Project	<b>IEEE 802.16 Broadband Wireless Access Working Group</b> < <a href="http://ieee802.org/16">http://ieee802.org/16</a> >	
Title	<b>Proposal for Modifying Information Model General View</b>	
Date Submitted	<b>2006-03-01</b>	
Source(s)	Zou Lan  Huawei Technologies. No.98,Lane91, Eshan Road, Pudong , Shanghai, China Pudong Lujiazui Software Park	Voice: +86-21-68644808-24657 Fax: +86-21-50898375 Mailto: <a href="mailto:zlan@huawei.com">zlan@huawei.com</a>
Re:	Contribution to IEEE 802.16i	
Abstract	This contribution proposed to modify general view of information model.	
Purpose	Adoption	
Notice	This document has been prepared to assist IEEE 802.16. It is offered as a basis for discussion and is not binding on the contributing individual(s) or organization(s). The material in this document is subject to change in form and content after further study. The contributor(s) reserve(s) the right to add, amend or withdraw material contained herein.

# Proposal for Modifying Information Model General View

Figure 6 General Containment/Naming Diagram

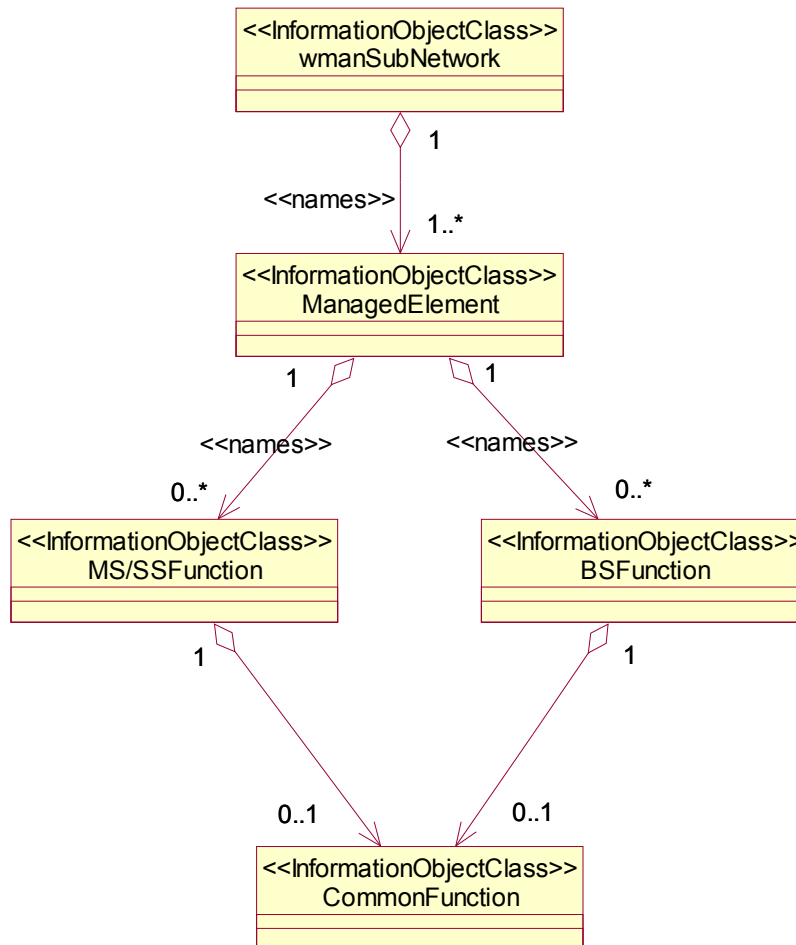
An BS object may contain the BS special attributes and also attributes defined in CommonFunction, there is containment relation between BSFunction class and CommonFunction class.

An MS/SS object may contain the MS/SS special attributes and also attributes defined in CommonFunction, there is containment relation between MS/SSFunction class and CommonFunction class.

This contribution is to modify the relation between BSFunction, MS/SSFunction and CommonFunction in Figure 6 and Figure 12.

*Replace Figure 6 and Figure 12 with proposed Figure below.*
